City of Surrey
ADDITIONAL PLANNING COMMENTS

Application No.: 7917-0427-00

Planning Report Date: June 5, 2023

to permit the development of a 5-storey apartment building with 45 rental units.

MAIN FLOOR PLAN

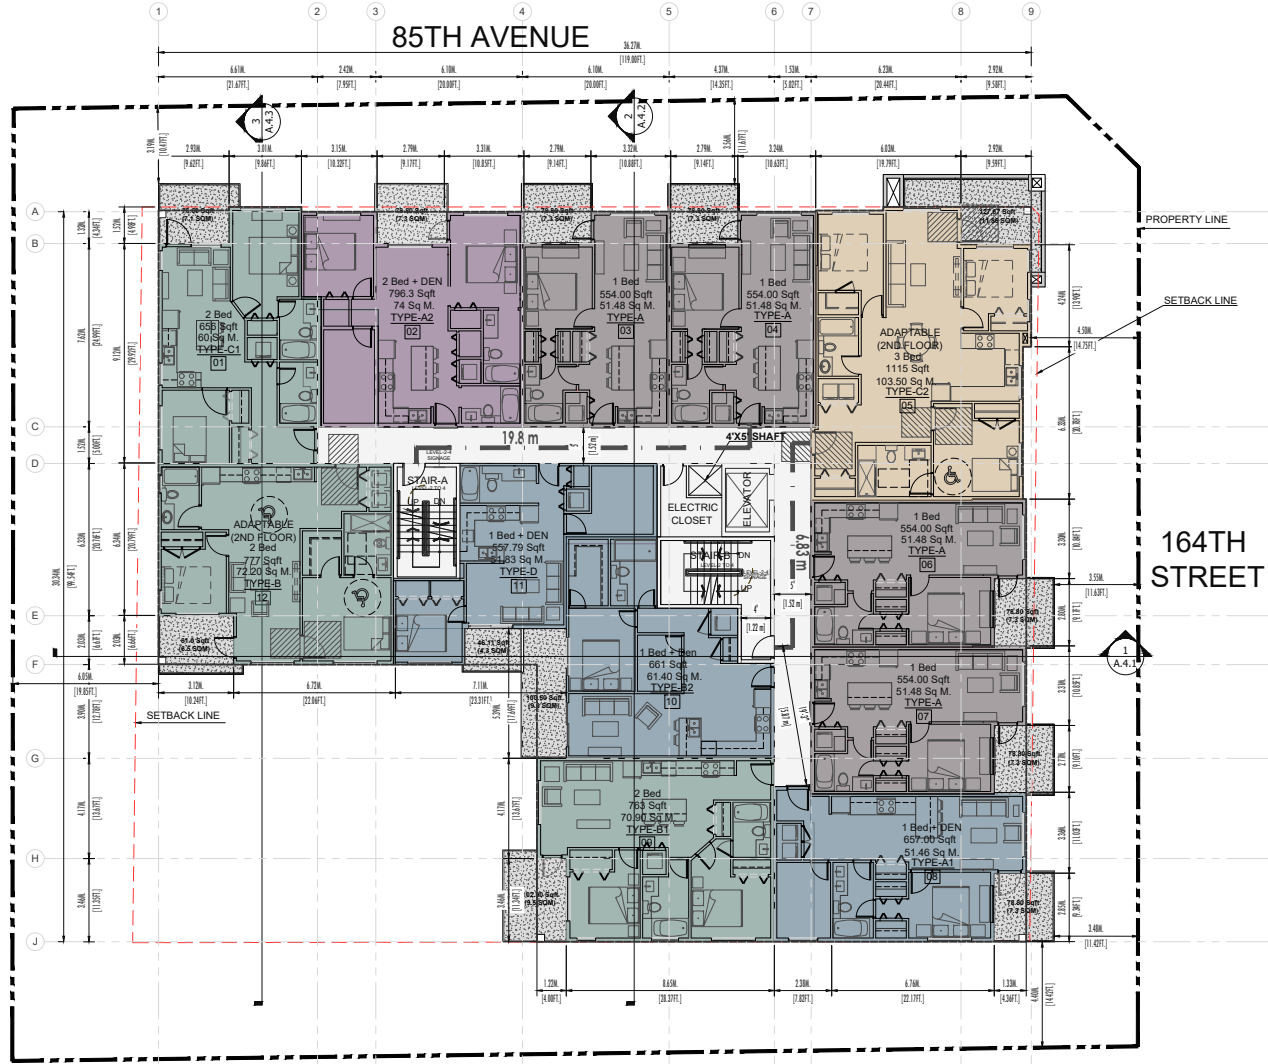
- Reconsider the bathroom windows above the entry in the wood panel as they are weakening the overall character of the building and negatively impacting the entry.
We have redesigned the unit layout and the entrance, and that window is for kitchen now. Updated, please refer to sheets ADP.3.1 to ADP.3.3 & ADP.2.2 (2nd Floor Plan) for more updates.
